GOVERNMENT OF INDIA
MINISTRY OF RAILWAYS
(RAILWAY BOARD)

No. 2013/CE-II/CS/6

Sub: Advance Correction Slip No. 135 to the Indian Railways Permanent Way Manual.

INDIAN RAILWAYS PERMANENT WAY MANUAL
ADVANCE CORRECTION SLIP No.135 dated .05.2014

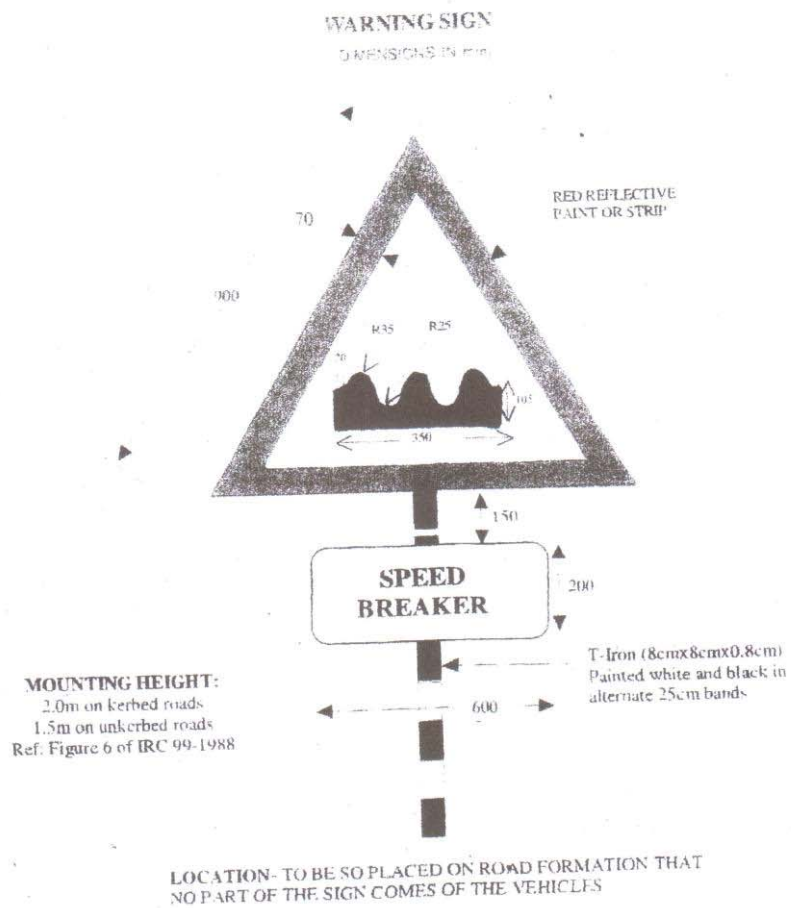
5. The existing Annexure-9/7 of Para 918 (2) shall be replaced by the new **Annexure-9/7 Para 918 (2)** as attached.

(Colour of speed breaker sign has been changed from Yellow to Black).

BALLAST PROFILE FOR LWR TRACK (SINGLE LINE B.G.)

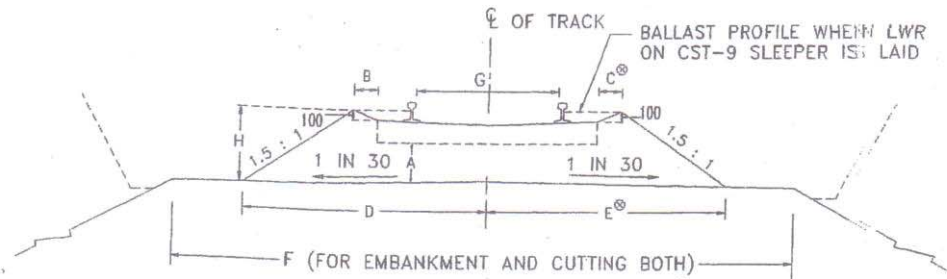
6. The existing Annexure-2/11 (Sketch and Table) and Annexure-2/13 (Sketch) of Para 263 of IRPWM shall be replaced by the new **Annexure-2/11 (Sketch and Table) and Annexure-2/13 (Sketch) of Para 263** as attached.
